## Clinton Power Station

Clinton Power Station, Unit 1  
Facility Operating License No. NPF-62  
NRC Docket No. 50-461

Subject: Request for License Amendment for Extended Power Uprate Operation

Figure 3.1.7-1 (page 1 of 1)  
Weight Percent Sodium Pentaborate Solution  
Concentration/Net Tank Volume Requirements

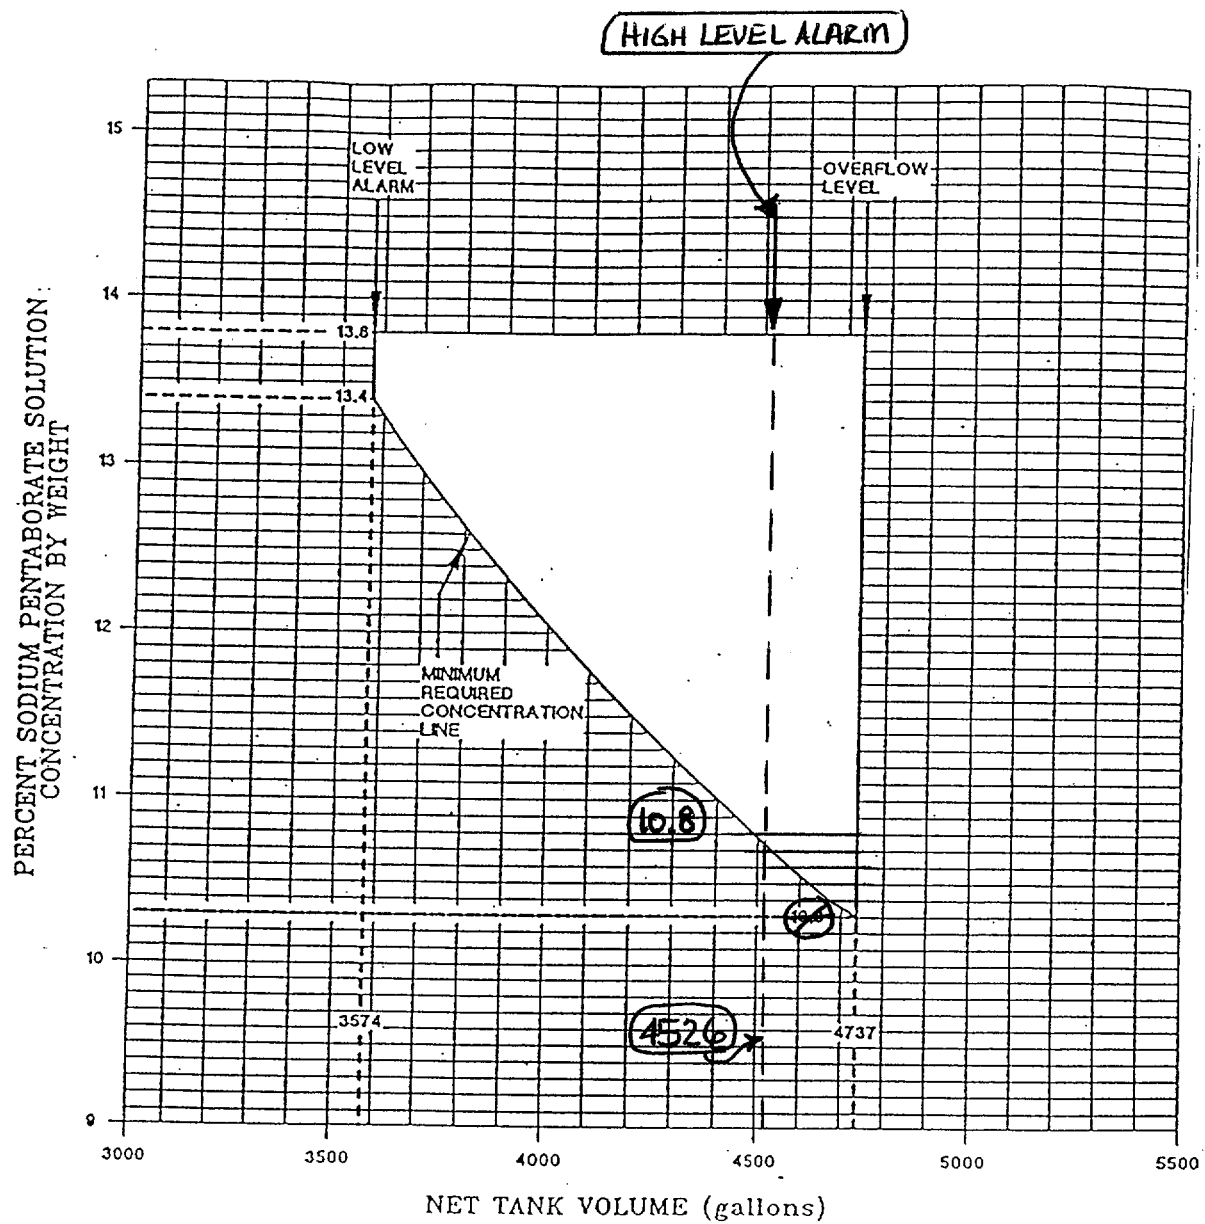
The proposed changes to TS Section 3.1.7, Figure 3.1.7-1 revise the SLC System concentration requirements. The Figure has been revised from a 10.3% to a 10.8% minimum allowable concentration.

TS Section 3.1.7, Figure 3.1.7-1 is revised to reflect a minimum SLC System weight percent concentration requirement from 10.3% to 10.8%.

The proposed changes to TS Section 3.1.7, Figure 3.1.7-1 revise the SLC System weight percent concentration versus volume requirements. The minimum allowable concentration as shown in the Figure has been revised from a 10.3% to a 10.8%. Replacement of the sodium pentaborate figure is consistent with the ATWS analysis in Section 9.3.1. Specific details supporting these changes are discussed in Section 6.5, "Standby Liquid Control System," of Attachment E.

Figure 3.4.1-1 (page 1 of 1)  
Thermal Power/Core Flow Stability Regions

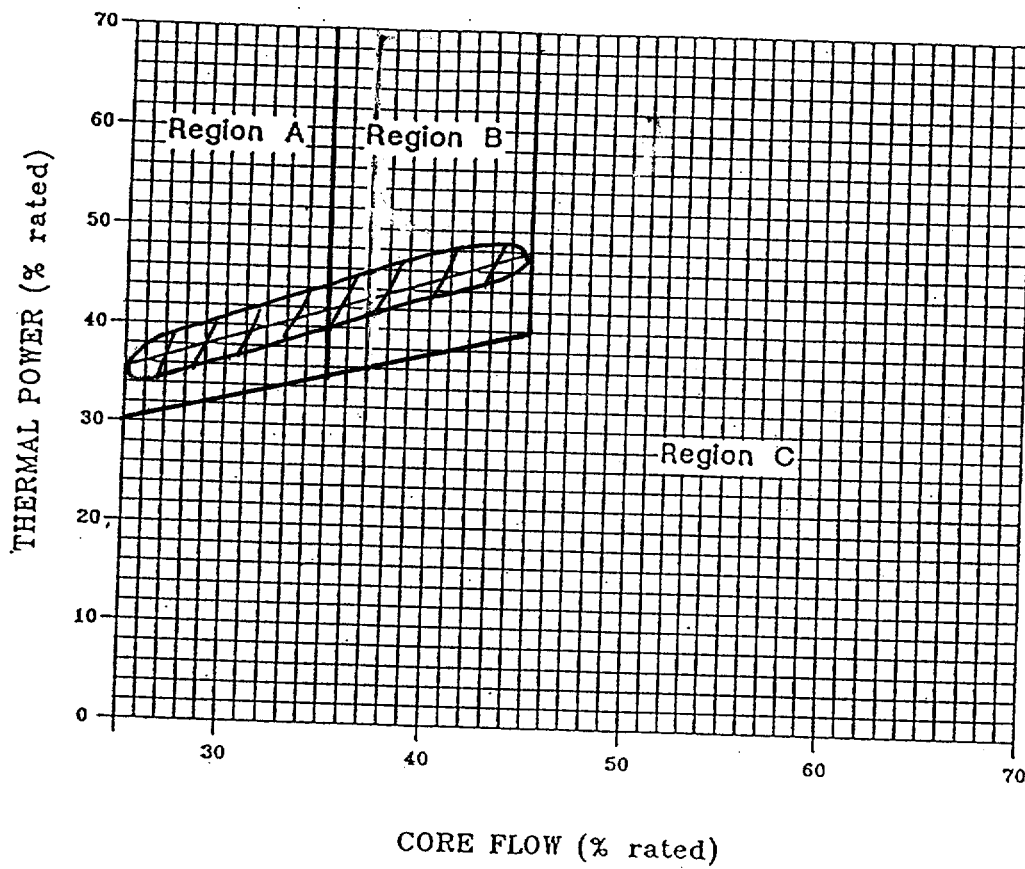
The proposed changes to the TS Limiting Condition for Operation (LCO), Required Action, and Figure 3.4.1-1 of TS Section 3.4.1 revise the percent RTP and corresponding operating region at which recirculation loops (i.e., single or both) shall be in operation. The percent RTP for the TS LCO has been revised from  $\leq 70\%$  RTP to  $\leq 58\%$  RTP. Similarly, the percent thermal power axis on Figure 3.4.1-1 has been re-scaled corresponding to the percent increase in power. The new percent RTP and stability limits are required to maintain the existing thermal power level under power uprate conditions.

TS LCO 3.4.1 is revised to state "THERMAL POWER  $\leq$  58% RTP." Required Action E.1 is revised to state "Reduce THERMAL POWER to  $\leq$  58% RTP." The RTPs have been revised from  $\leq$  70% RTP to  $\leq$  58% RTP. Condition E is revised to state "THERMAL POWER  $>$  58% RTP during single recirculation loop operation." The RTP has been revised from  $>$  70% RTP to  $>$  58% RTP. TS Figure 3.4.1-1 is revised to reflect the revised limits pertaining to the re-scaling of the thermal power axis.

The proposed changes to the LCO, Required Action, and Figure 3.4.1-1 of TS Section 3.4.1 revise the percent RTP and corresponding operating region at which recirculation loops (single or both) shall be in operation. The percent RTP for the LCO has been revised from  $\leq 70\%$  RTP to  $\leq 58\%$  RTP. Similarly, the percent thermal power axis on Figure 3.4.1-1 has been re-scaled corresponding to the percent increase in power. The new percent RTP and stability limits are required to maintain the existing thermal power level. For EPU, the thermal power has been reduced corresponding to the ratio of the power increase (i.e., 2894/3473). Specific details supporting these changes are discussed in Section 3.4, "Reactor Recirculation System," of Attachment E.
